Consent Agenda Item (Action Item): Consider/Approve Change Order #4 for the Duff Allen Central Elementary renovation project.

**Proposed Change Orders for April 2026 Floyd County Schools
BG#24-293 Duff Allen Central Elementary Renovation**

BG#24-293 Duff Allen Central Elementary Renovation

CP-22 Pump Performance Curve

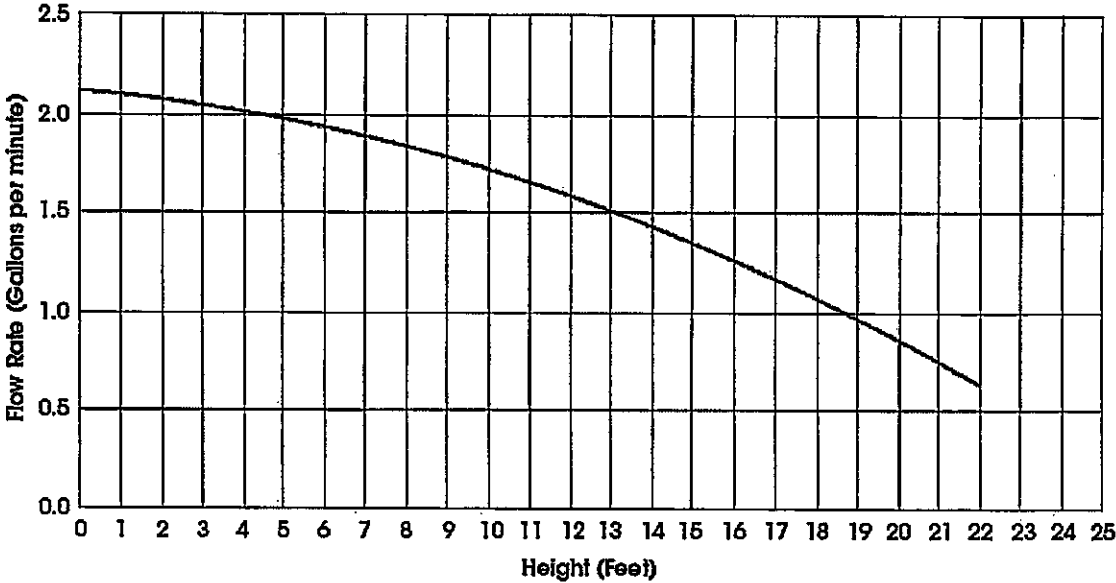
RE: Revised condensate pump pricing per conversation with STW. Electrical is priced to use closest existing circuit. Condensate pumps pricing is labor install only. Cutsheet attached of pumps being used for your review.

1 FIRST FLOOR - MECHANICAL DEMOLITION - AREA A
SCALE: 1/8" = 1'-0"

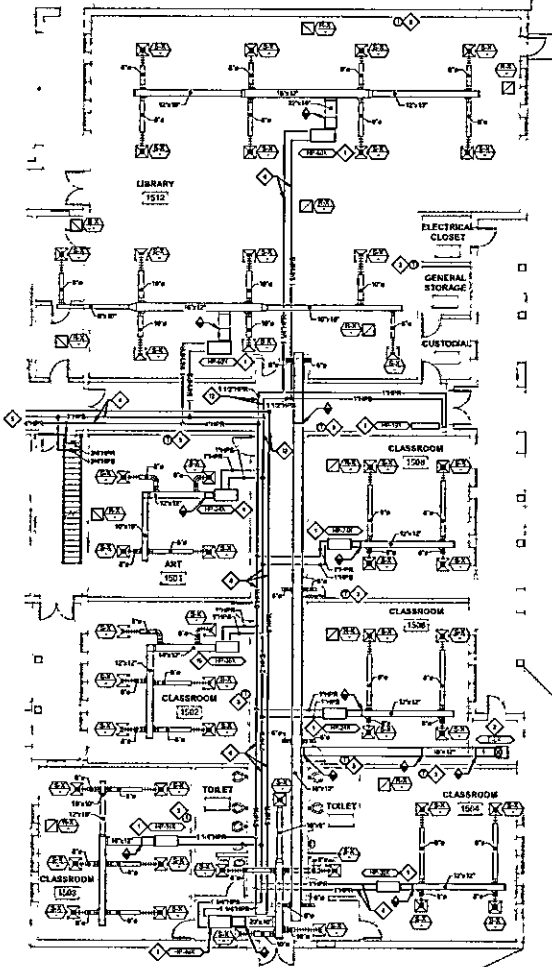
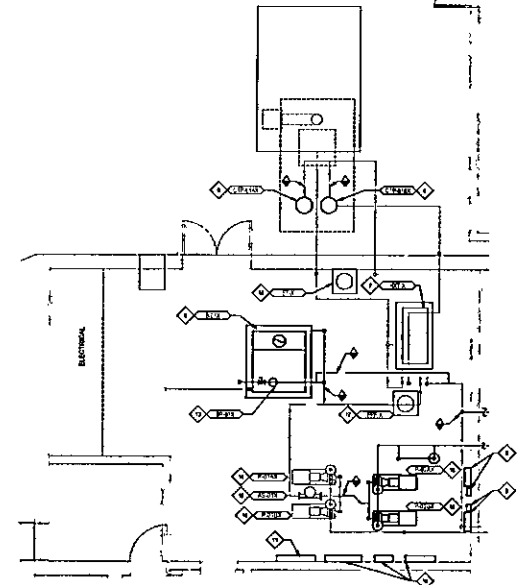
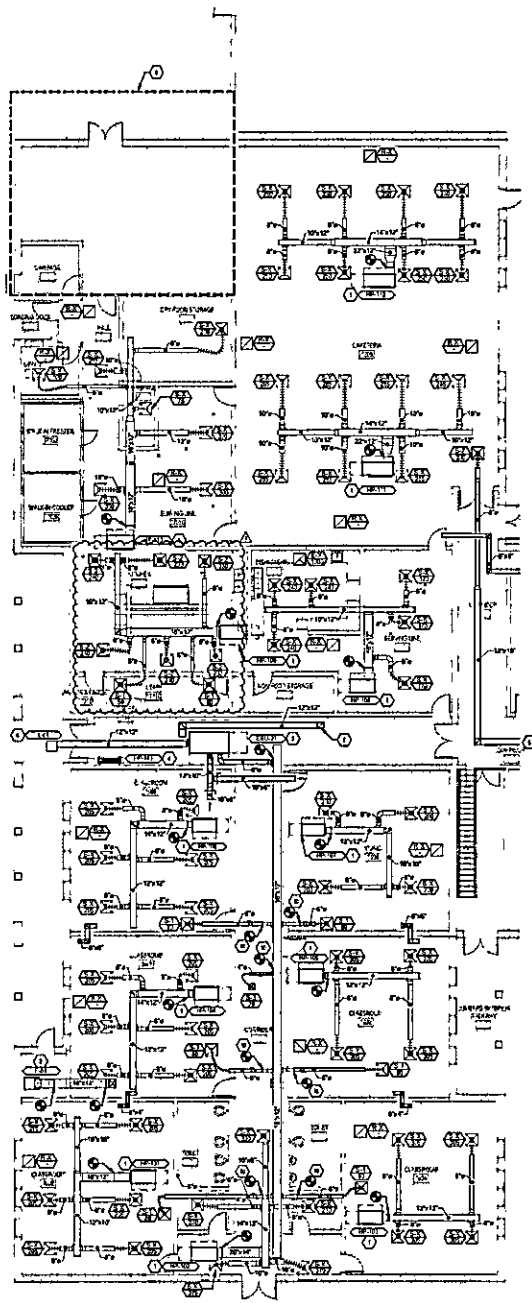
Demolish all existing supply and return grilles in the kitchen area.

Provide new ceiling grilles as indicated on attached drawing. Grilles shall reconnect to existing flex duct in existing location.

M103

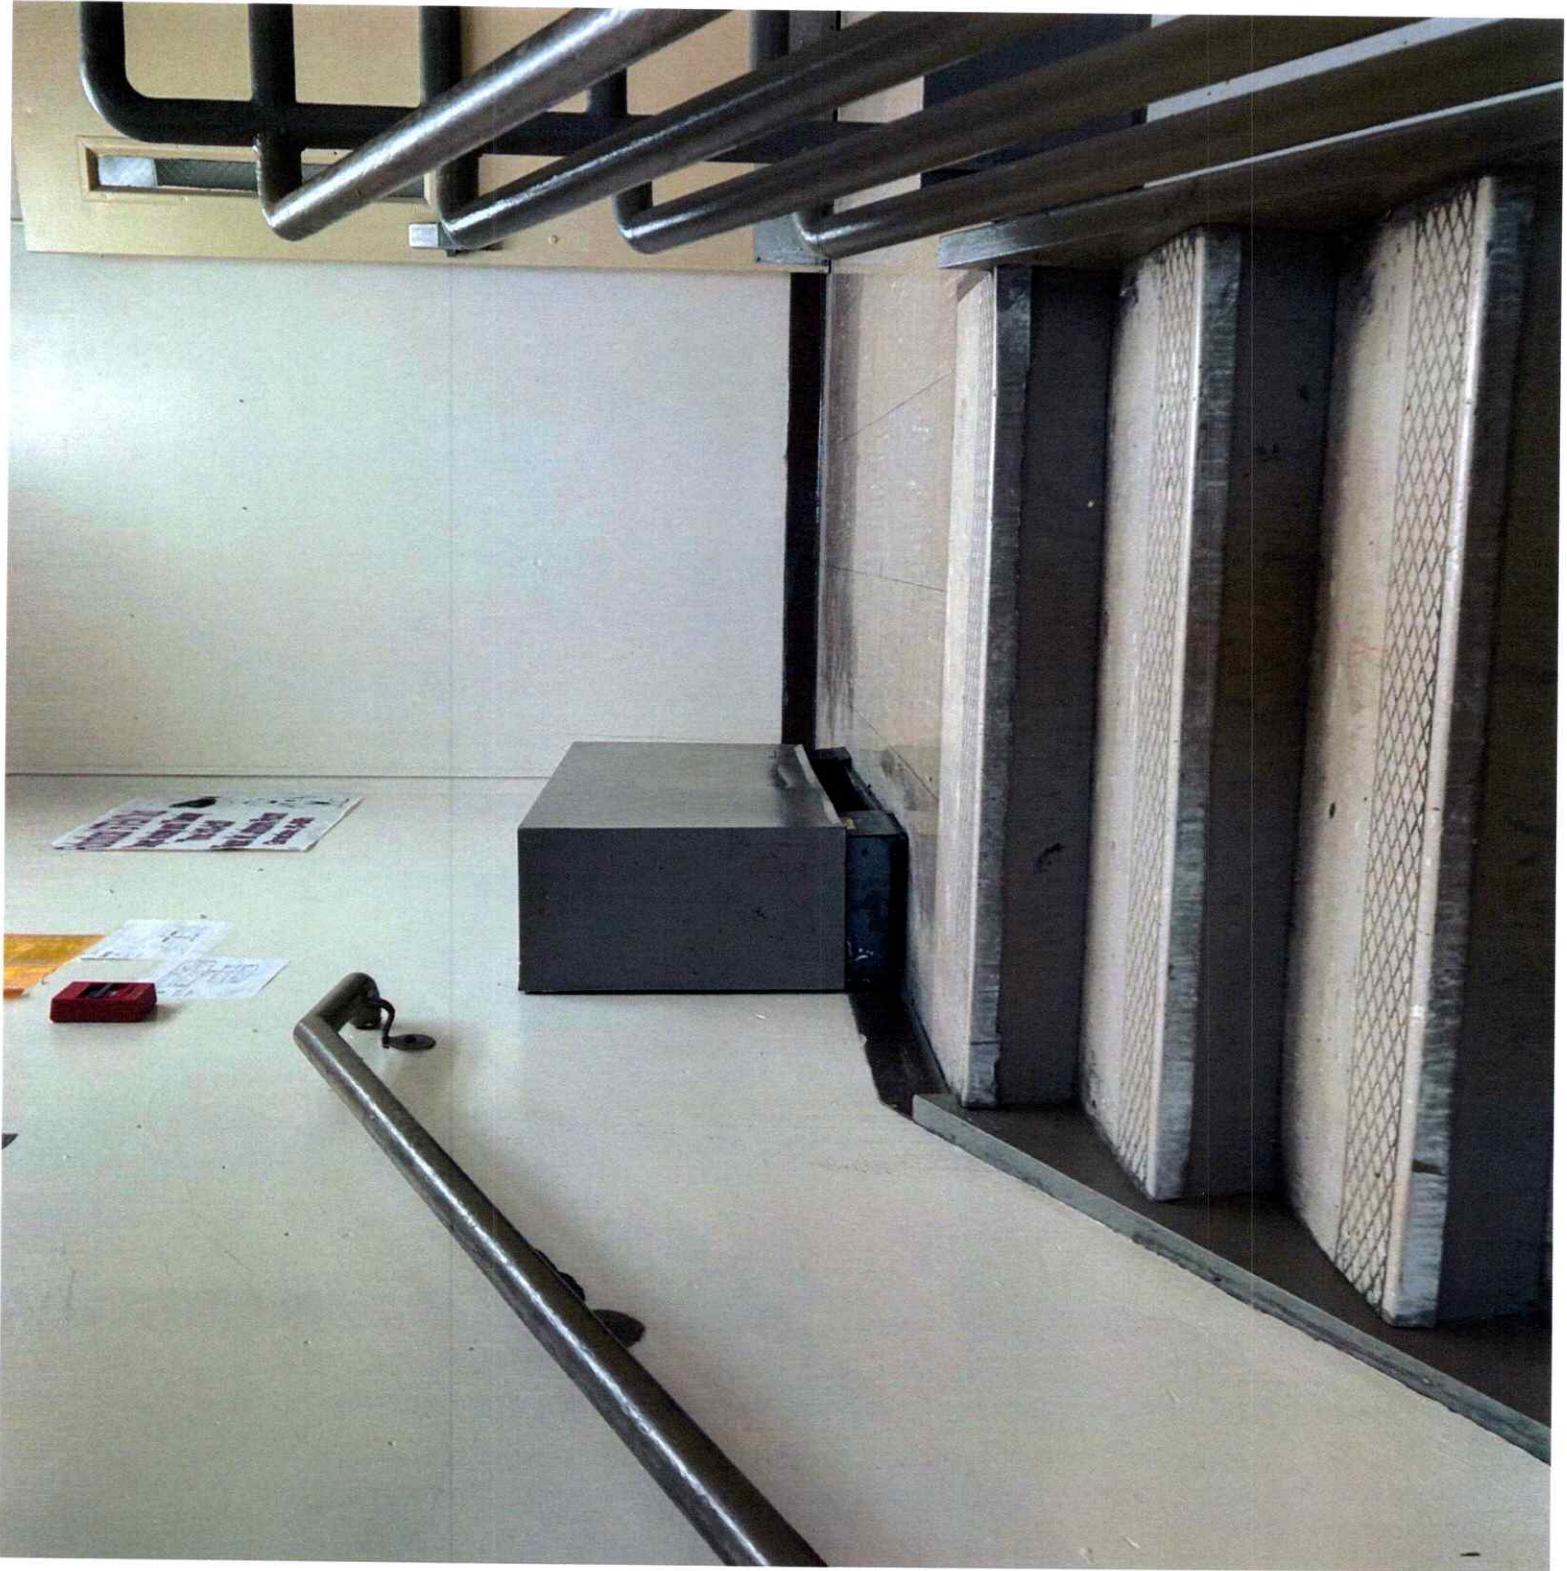
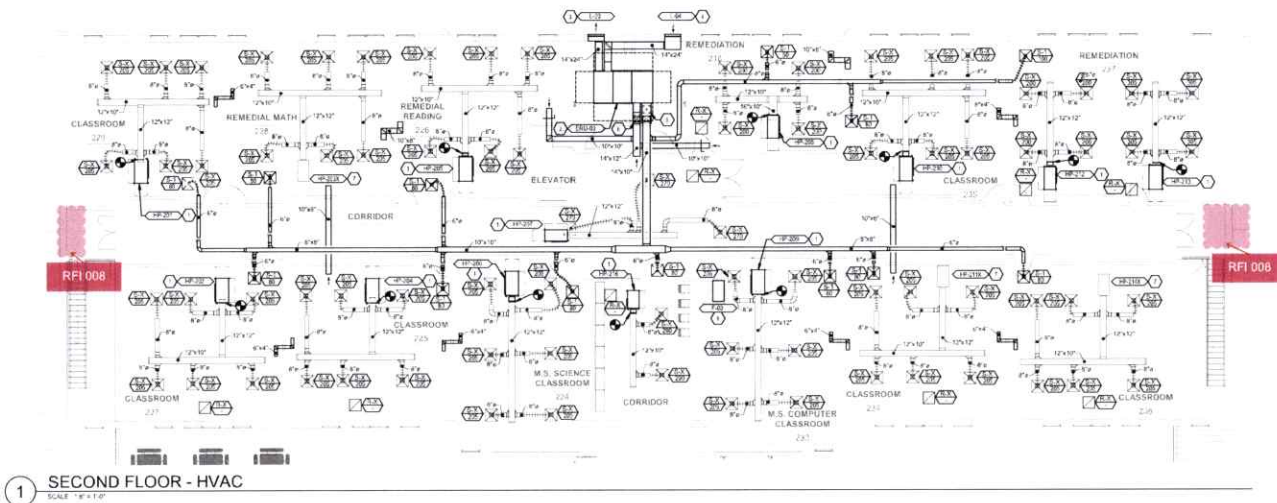
There is console units in at the top of each stair ware on second floor. It doesn't show anything on these units, Demo/Replace. Where these missed and what action do we need to take

There is console units in at the top of each stair ware on second floor. It doesn't show anything on these units, Demo/Replace. Where these missed and what action do we need to take

Provide pricing to replace the units. Including, equipment, mechanical labor, controls, and electrical.
